Agenda Item # 8

SUB-003849-2026 & SUB-SW-003850-2026

Roote Subdivision

- Subdivision approval to create one (1) legal lot of record.
- Waive construction of sidewalks along Government Boulevard.

SITE PLAN

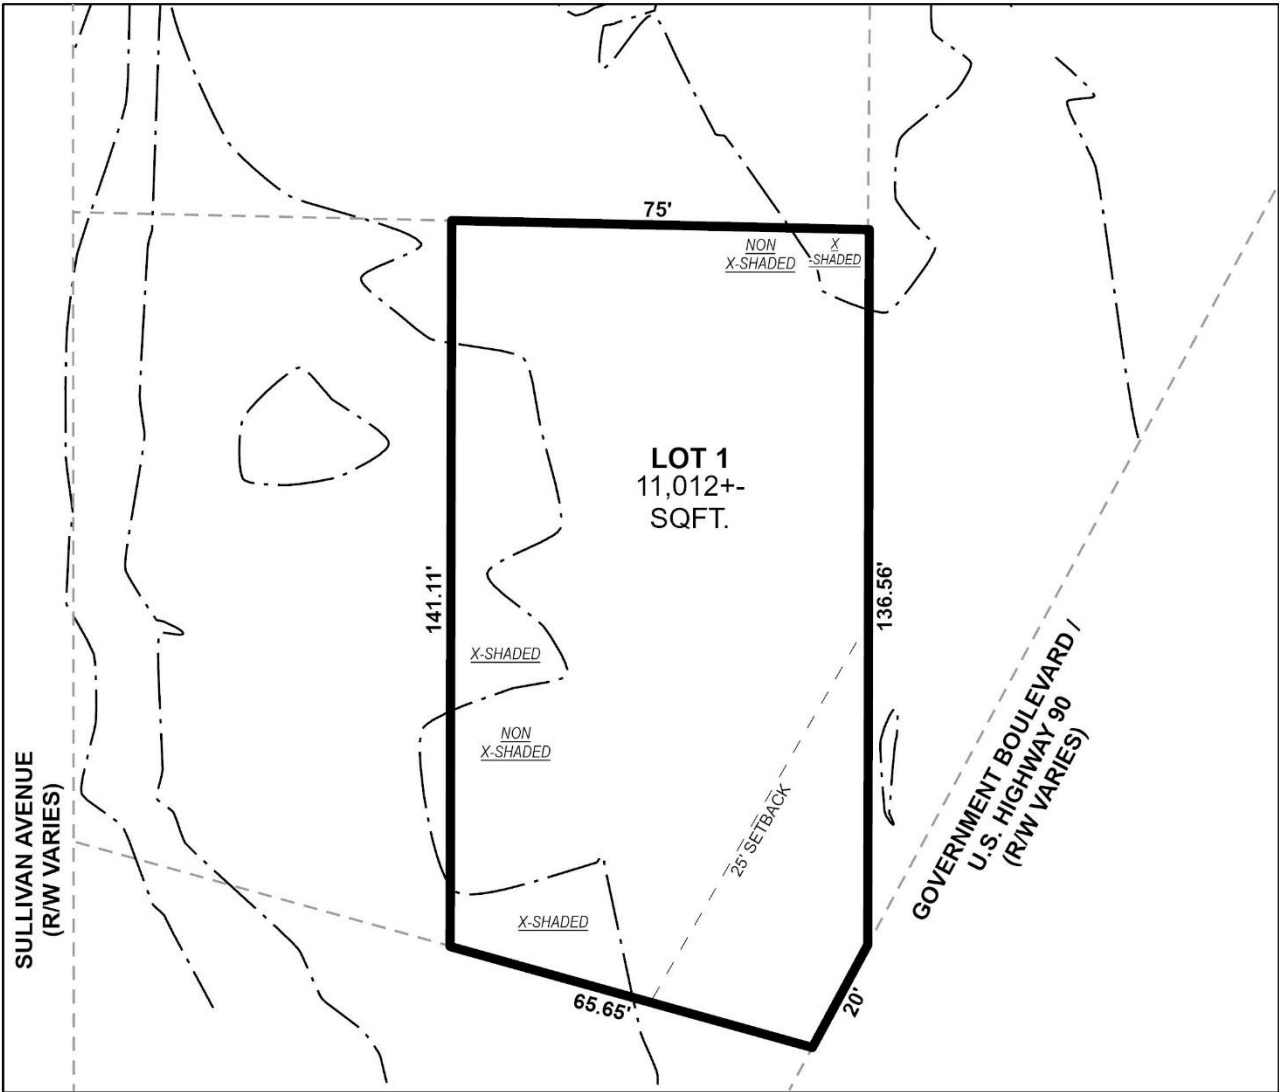
The site has frontage on Government Boulevard, an Alabama Department of Transportation (ALDOT)-controlled right-of-way, and a principle arterial street that should have a 250-foot-wide right-of-way. The preliminary plat submitted depicts the right-of-way as varying, therefore, if approved, the plat should be revised to either depict that there is an existing right-of-way of 125-feet to the centerline from the subject site, or provide such dedication.

The proposed lot has approximately 20 feet of street frontage. Section 6.C.2.(b)(4) of the Subdivision Regulations requires newly platted commercial lots in a Suburban sub-district to have a minimum of 60 feet of street frontage. Therefore, if approved, a waiver of Section 6.C.2.(b)(4) of the Subdivision Regulations will be required.

The preliminary plat illustrates the required 25-foot minimum front yard setback along the entire frontage. However, it appears that the setback is not depicted accurately, as it increases to over 53-feet from the east property line. If approved, the front setback should be revised to accurately be depicted at 25 feet across the entire property frontage.

The preliminary plat indicates the proposed lot size in both square feet and acres. If approved, this information should be retained on the Final Plat, adjusted for any dedication required.

1. Either dedication to provide 125 feet to the centerline along Government Boulevard or illustration that such right-of-way currently exists;
2. Retention of the lot's size in square feet and acres, or provision of a table on the Final Plat with the same information, adjusted for dedication;
3. Revision of the plat to accurately depict the 25-foot minimum front yard setback line along the entire frontage;
4. Compliance with all Engineering comments noted in this staff report;
5. Placement of a note on the Final Plat stating all Traffic Engineering comments noted in this staff report;
6. Compliance with all Urban Forestry comments noted in this staff report; and,
7. Compliance with all Fire Department comments noted in this staff report.
